# Access Compliance Report

## Public Rights-of-Way

### (Curb Ramps)

Intersection ID: 50517	Main Street: STEWART TERRACE_WY	Cross Street: MICHAEL CROSSING_DR	Location: NE
ADA ID: 116A3604691F	Ramp Type: PerpDiag	Initial Pass/Fail: Fail	Overall Compliance: No
Severity Score: 12.5			
Codes/Mitigation Info/Possible Solution		Field Measurements/Component Compliance

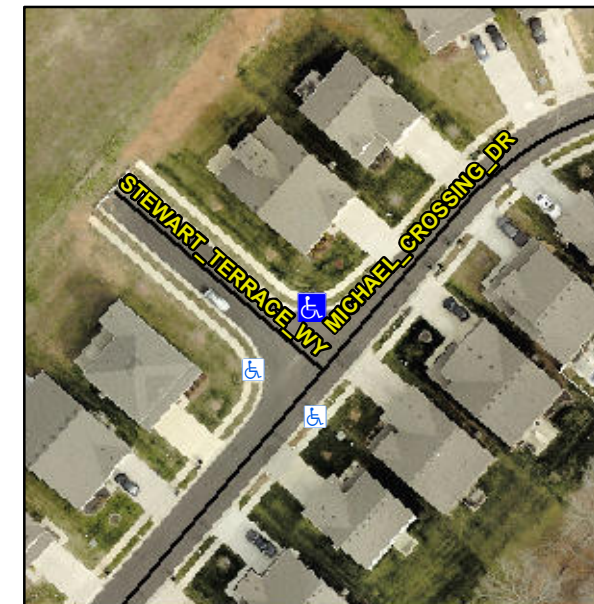
**Not Found, R304.2.2**

Compliance	Description	Data	Compliance	Description	Data
N/A	Ramp Length (in)	46.5	No	Ramp Slope (%)	10.5
Yes	Ramp Width (in)	48.0	Yes	Ramp XSlope (%)	1.8
N/A	Flare Type LT	N/A	N/A	Flare Type RT	N/A
N/A	Flare Slope LT (%)	N/A	N/A	Flare Slope RT (%)	N/A
N/A	Flare Traversable LT?	N/A	N/A	Flare Traversable RT?	N/A
N/A	Landing Length (in)	N/A	N/A	DWS Provided?	N/A
N/A	Landing Width (in)	N/A	N/A	DWS Contrast?	N/A
N/A	Landing Slope (%)	N/A	N/A	DWS Length (in)	N/A
N/A	Landing X Slope (%)	N/A	N/A	DWS Full Width?	N/A
N/A	Landing Curb? (Y/N)	N/A	N/A	DWS Offset (in)	N/A
N/A	Shared Landing?	N/A			
N/A	Gutter Ponding?	N/A	N/A	Gutter Slope (%)	N/A
N/A	Gutter Lip Ht (in)	1.5	N/A	Gutter X Slope (%)	N/A
N/A	Painted X Walk1?	No	N/A	Painted X Walk2?	No
	X Walk 1 Direction	To SW		X Walk 2 Direction	To SE
N/A	X Walk 1 Width (in)	N/A	N/A	X Walk 2 Width (in)	N/A
	X Walk 1 Slope (%)	1.7		X Walk 2 Slope (%)	1.2
	X Walk 1 X Slope (%)	2.8		X Walk 2 X Slope (%)	0.7

**Remove & Replace Curb Ramp With Two New Directional Ramps or Equivalent.**
